**OFFICE OF ENVIRONMENTAL
SUSTAINABILITY**

**INSPECTOR'S REPORT ON AN APPLICATION
FOR A CERTIFICATE OF AUTHORISATION
FOR A CLOSED LANDFILL**

TO:	Gerard O'Leary, Director	
FROM:	Ewa Babiarczyk, Inspector,	Environmental Licensing Programme
DATE:	18 th June 2021	
RE:	Application by Kildare County Council for a Certificate of Authorisation for a closed landfill at Prusselstown, Athy, County Kidare . Certificate of Authorisation Register Number H0209-01 .

Figure 2: Site layout & surroundings and site investigation locations

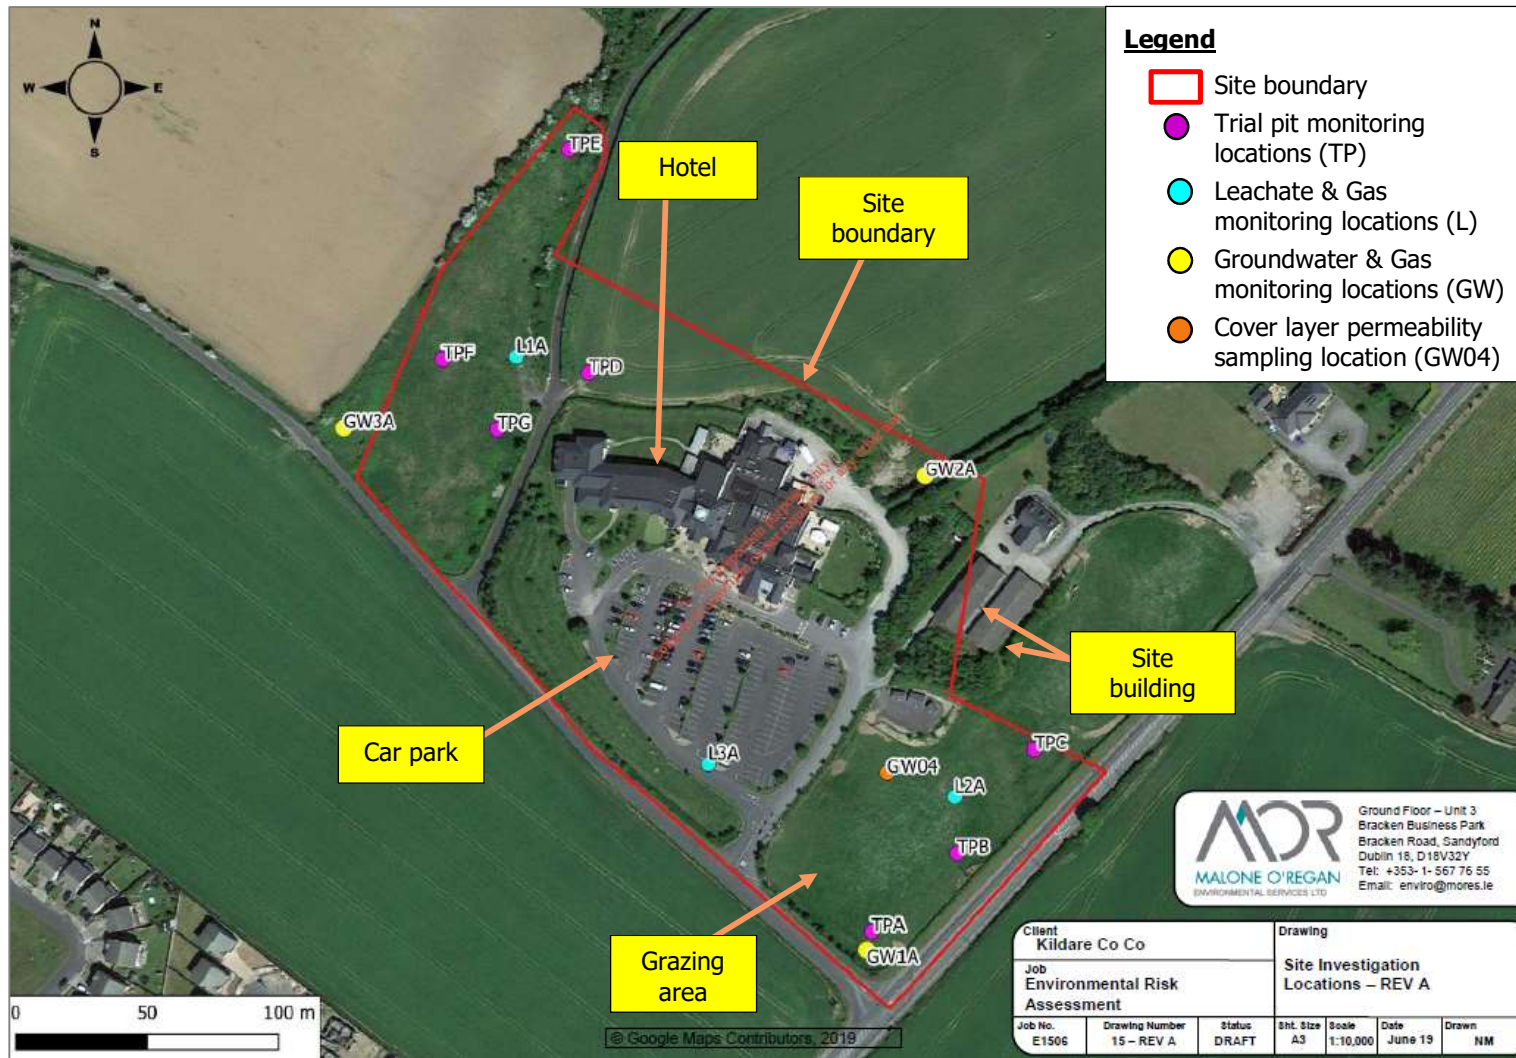
Leachate monitoring was carried out at combined (leachate and gas) monitoring boreholes L1A, L2A and L3A within the waste body, as shown in Figure 2, on 25th April 2019 and 9th May 2019.

Leachate samples were retrieved from the monitoring location L1A only. No leachate samples could be retrieved from L2A or L3A because these monitoring locations were dry during both monitoring events. The waste encountered in the boreholes included plastic, red bricks, wood, cloths, concrete, metal, clothes, glass, half burnt tyre and refuse bags.

The monitoring results show that a number of parameters in the landfill leachate exceeded the relevant standards. Furthermore, it cannot be determined whether the actual concentrations for benzo(a)pyrene and total PAHs were within the relevant standards as the limit of detection for the monitoring methods are above the EQSs.

Condition 3.9(b) requires leachate monitoring in the existing wells L1A, L2A and L3A on a quarterly basis and specifies the minimum parameters to be monitored, including PAHs, to ensure that the on-going levels are monitored.

Figure 4: Surface Water Monitoring locations

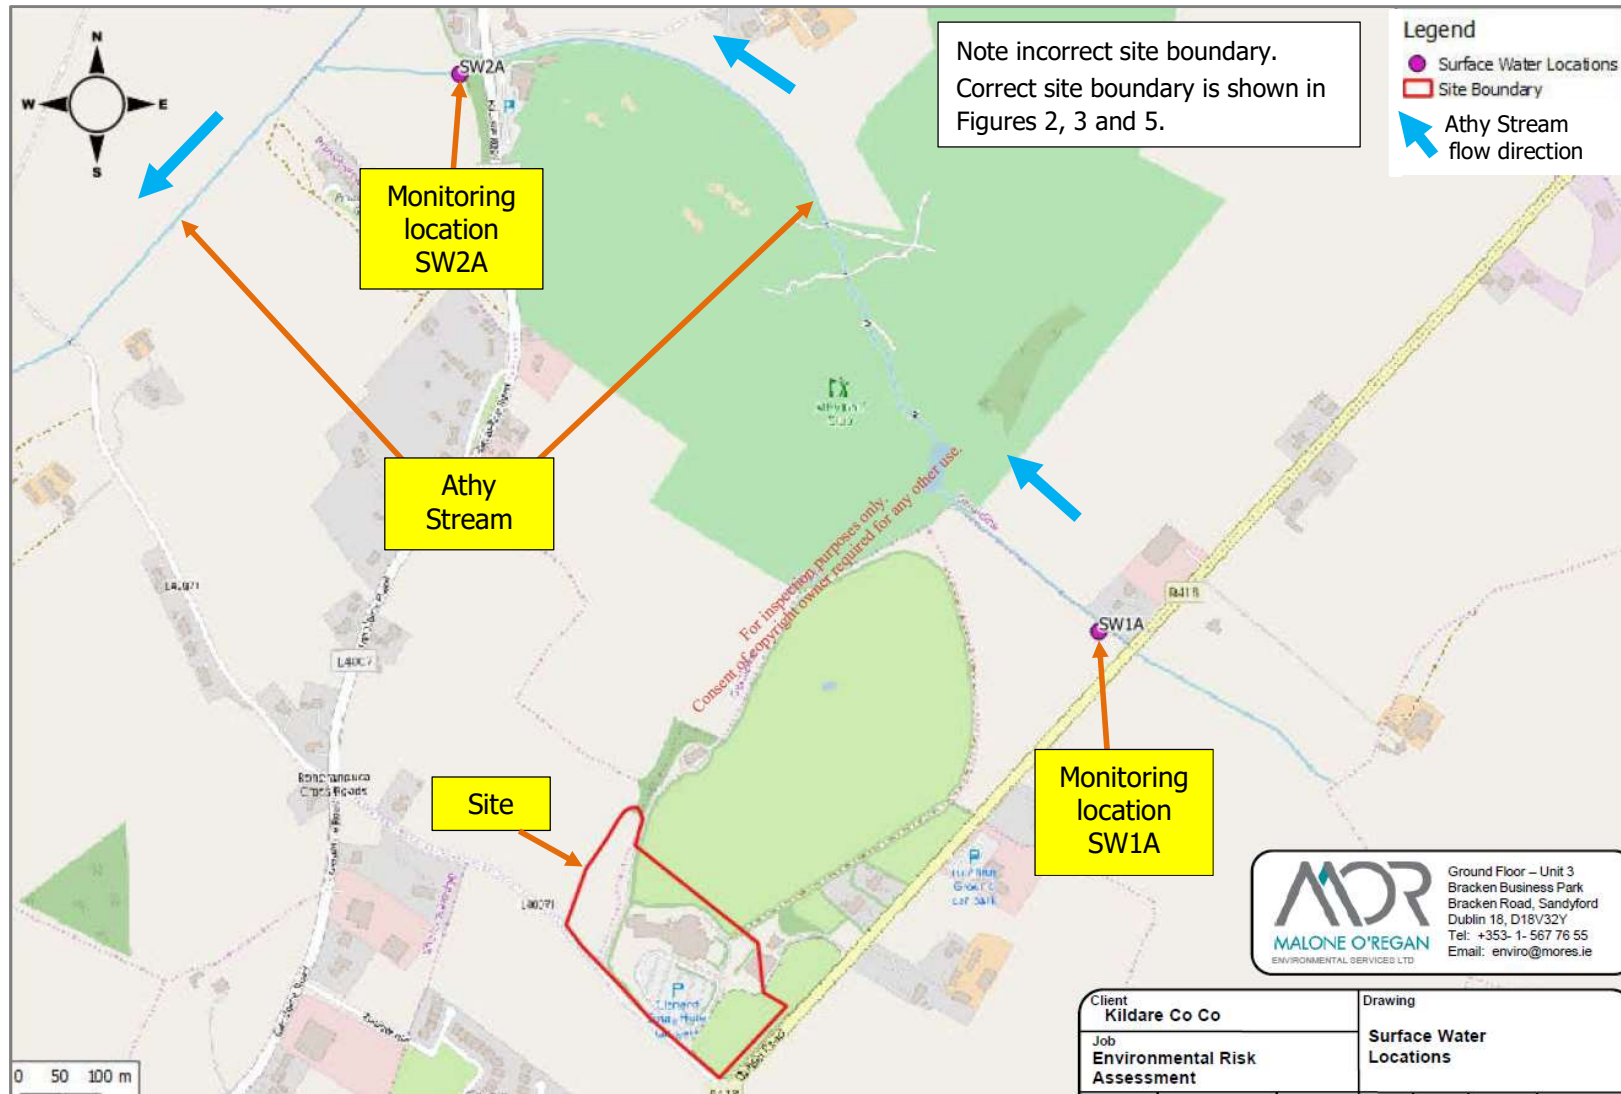
Two surface water samples, SW1A and SW2A, were collected from the Athy Stream on 25th April 2019 and 9th May 2019, as shown in Figure 4. SW1A is located 616m north-east of the site and SW2A is located 940m north of the site. It is noted however that both of these monitoring locations are located upstream of the landfill. It is also noted however that the nearest downstream monitoring location to the landfill, would have to be on the Barrow River, approximately 4km south-west of the site. Monitoring of downstream surface water quality at such a distance from the closed landfill is however not considered practical, particularly when taking into account the existing discharges to the river as outlined above. Accordingly, it is considered that the impact of the closed landfill can be monitored through the assessment of groundwater quality, as recommended in Section titled *Hydrogeology* below.

The monitoring results show that most of the monitored parameters were within their environmental quality standards (EQS) set out in *European Communities Environmental Objectives (Surface Water) Regulations 2009, as amended*. It is noted however, that it cannot be determined whether the actual concentrations for Chromium, Copper, Cadmium, Lead, Mercury, Tributyltin, Dichlorvos and polycyclic aromatic hydrocarbons (PAHs, including, but not limited to, fluoranthene, benzo(a)pyrene, benzo(bk)fluoranthene and benzo(ghi)perylene), were within the relevant standards as the limit of detection for the monitoring methods utilised were above the EQS. Furthermore, the monitoring results show that the concentrations of a number of parameters at SW2A slightly exceed the concentrations at SW1A, indicating a slight deterioration in water quality. Considering however, that the groundwater beneath the site flows towards the south/ south-west, as shown in Figure 5, it is unlikely that the landfill could impact the water quality in the Athy Stream.

Condition 3.9(d) requires quarterly monitoring of the Athy Stream at the monitoring locations SW1A and SW2A. In addition, Condition 3.9(g) requires that the sensitivity of the monitoring methods utilised shall have an appropriate limit of detection to allow for comparison of pollutant concentrations against the relevant trigger levels and/or standard reference values.

Figure 5: Groundwater flow direction

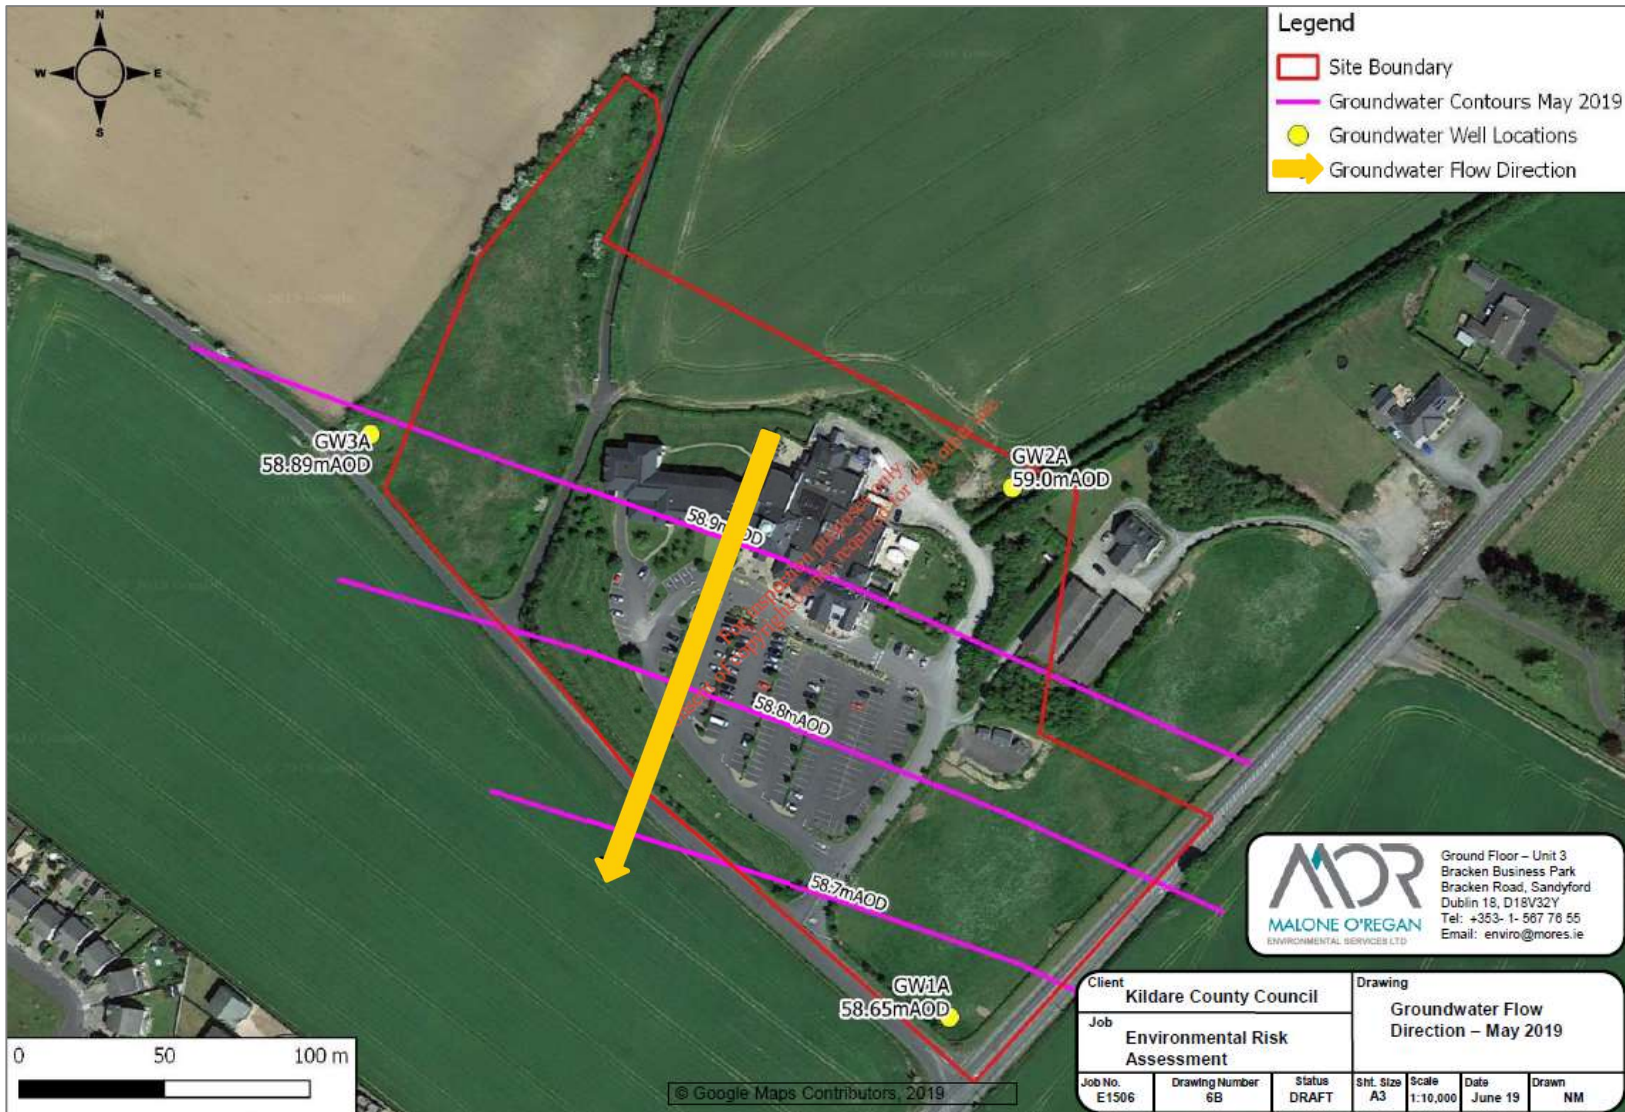
Considering that the groundwater flow beneath the site is towards the south/ south-west, it is noted that only monitoring borehole GW1A is

located downgradient of the waste body. The monitoring location GW3A is located outside the site boundary near the north-western corner of the site. Considering the direction of the groundwater flow, as shown in Figure 5, and the location of waste in this area of the site, it is noted that borehole GW3A may not be fully representative of downgradient ground water conditions. Accordingly, Condition 3.1(d) requires the installation of an additional groundwater monitoring borehole downgradient of the waste body (monitoring location GW4A).
